Access Compliance Report

Public Rights-of-Way

(Curb Ramps)

Intersection ID: 49789	Main Street: BARLEY_LN	Cross Street: GRASS_DR	Location: E
ADA ID: 62580CDE1A41	Ramp Type: Perp	Initial Pass/Fail: Fail	Overall Compliance: No
			Severity Score: 13.75

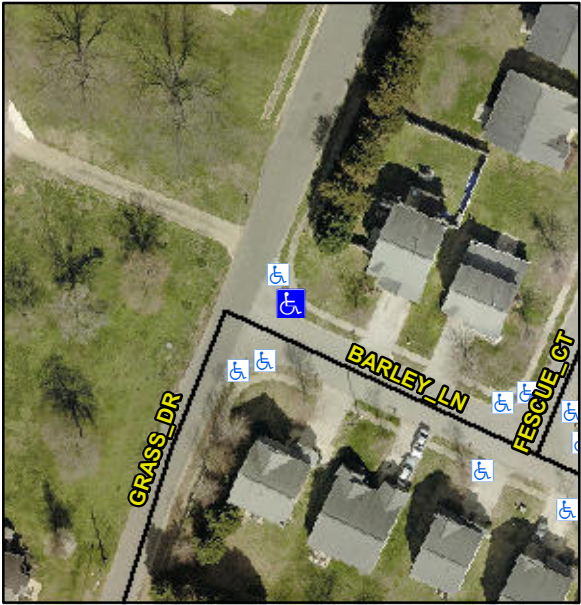
Codes/Mitigation Info/Possible Solution			Field Measurements/Component Compliance		
	Possible Solutions:		Compliance	Description	Data
	Remove & Replace Entire Ramp.		No	Ramp Length (in)	48.0
			Yes	Ramp Width (in)	48.0
			N/A	Flare Type LT	N/A
			N/A	Flare Slope LT (%)	N/A
			N/A	Flare Traversable LT?	N/A
			N/A	Landing Length (in)	N/A
			N/A	Landing Width (in)	N/A
			N/A	Landing Slope (%)	N/A
			N/A	Landing X Slope (%)	N/A
<p>Surveyor Notes:</p> <p>N/A</p> <p>PROW/ADA:</p> <p>Not Found, R304.2.2, R304.5.3</p>			N/A	Flare Type RT	N/A
			N/A	Flare Slope RT (%)	N/A
			N/A	Flare Traversable RT?	N/A
			N/A	DWS Provided?	N/A
			N/A	DWS Contrast?	N/A
			N/A	DWS Length (in)	N/A
			N/A	DWS Full Width?	N/A
			N/A	DWS Offset (in)	N/A
			N/A	Gutter Ponding?	N/A
			N/A	Gutter Lip Ht (in)	N/A
			No	Painted X Walk1?	N/A
			To SW	X Walk 1 Direction	N/A
			N/A	X Walk 1 Width (in)	N/A

1.5	X Walk 1 Slope (%)	N/A
			2.8	X Walk 1 X Slope (%)	N/A
			N/A	Ramp inside XWalk1?	N/A
			N/A	Road Slope (%)	N/A
			N/A	Road X Slope (%)	N/A
			N/A	Any Obstructions?	N/A
			N/A	Obstruction Type	N/A
Total Cost:			\$	1850.00	
			N/A		N/A
			Yes	Surface Condition? (G/P)	Good
